Model: Model PL-P1	Date: 25-Jun-04	No.: RG108001d
--------------------	-----------------	----------------

Subject: Firmware Release History (printer)		Prepared by: H.K.	
From: 1st Tech. Support Sec. Service Support Dept.			
Classification:	<input type="checkbox"/> Troubleshooting	<input type="checkbox"/> Part information	<input type="checkbox"/> Action required
	<input type="checkbox"/> Mechanical	<input type="checkbox"/> Electrical	<input type="checkbox"/> Service manual revision
	<input type="checkbox"/> Paper path	<input type="checkbox"/> Transmit/receive	<input type="checkbox"/> Retrofit information
	<input type="checkbox"/> Product Safety	<input checked="" type="checkbox"/> Other (Firmware History)	<input type="checkbox"/> Tier 2

Model: Model PL-P1		Date: 6-Jul-04	No.: RG108005
Subject: Service manual correction		Prepared by: H.Tagucghi	
From: 1st Tech. Support Sec. Service Support Dept.			
Classification:	<input type="checkbox"/> Troubleshooting	<input type="checkbox"/> Part information	<input type="checkbox"/> Action required
	<input type="checkbox"/> Mechanical	<input type="checkbox"/> Electrical	<input checked="" type="checkbox"/> Service manual revision
	<input type="ch

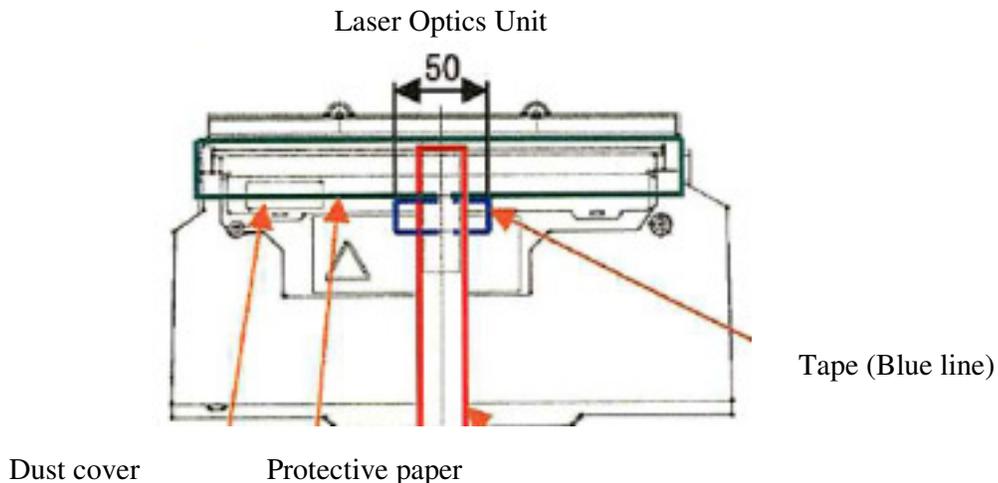
The dust cover for the optics unit comes loose and blocks the laser.

Sometimes, customers reach through the top cover and remove the protective sheet for the optics unit. In some cases, the dust cover opens and then comes loose when the toner cartridge is pushed in.

If the symptom is reported, close the dust cover or replace it if it is broken.

A strip of tape was added to the dust cover to keep it closed.

**Important:** You do not need this tape after installation. Remove the tape if you need to open the cover to do regular maintenance (for example, to clean the dust glass).
